Title: CR 25.214-033: Uplink TX timing adjustment

Document for: Decision

Figure 2: Synchronization establishment flow upon intra/inter-cell soft handover

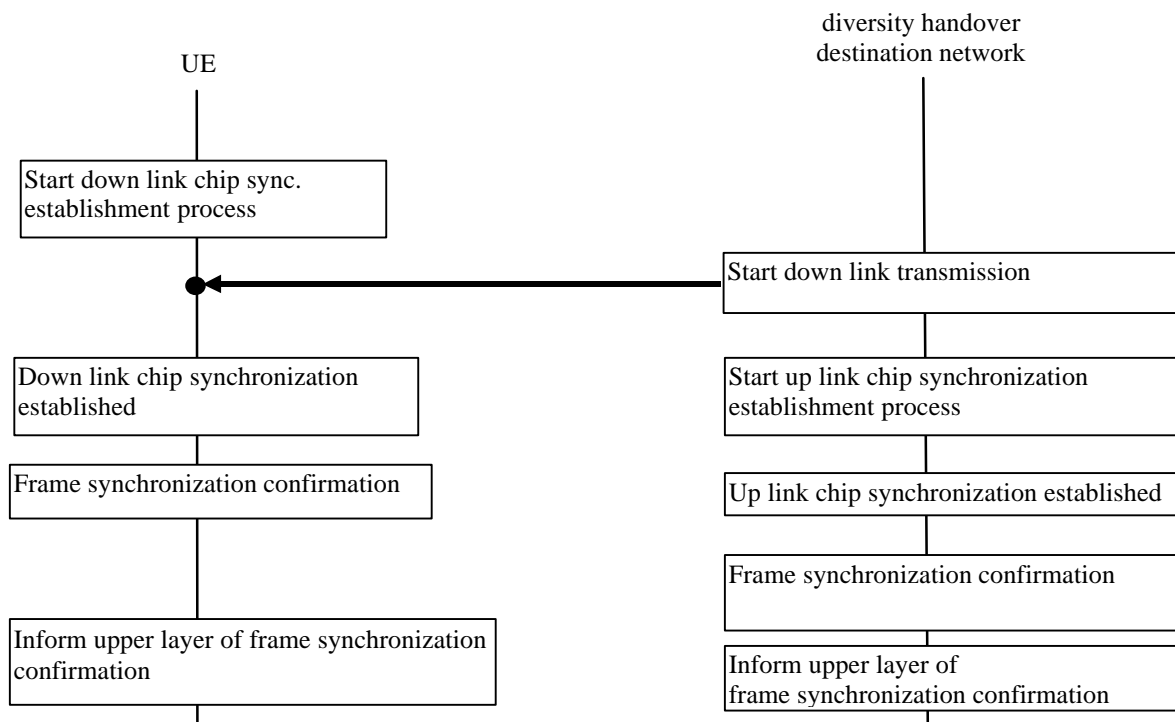
The synchronisation establishment flow upon intra/inter-cell soft handover is described in figure 2.

- a) The UE starts the chip synchronisation establishment process of downlink channels from the handover destination. The uplink channels being transmitted shall continue transmission as before.

- b) UTRAN starts the transmission of the downlink DPCCH/DPDCH at a frame timing such that the frame timing received at the UE will be within $T_0 \pm [148]$ chips prior to the frame timing of the uplink DPCCH/DPDCH at the UE. UTRAN then starts the synchronization establishment process of the uplink DPCCH/DPDCH transmitted by the UE. Frame synchronization can be confirmed using the Frame Synchronization Word. Successful frame synchronization is confirmed and reported to the higher layers when S_R successive frames have been confirmed to be frame synchronized. Otherwise, frame synchronization failure is reported to the higher layers.

- c) Based on the handover destination CPICH reception timing, the UE establishes chip synchronisation of downlink channels from handover destination cell. Frame synchronization can be confirmed using the Frame Synchronization Word. Successful frame synchronization is confirmed and reported to the higher layers when S_R successive frames have been confirmed to be frame synchronized. Otherwise, frame synchronization failure is reported to the higher layers.
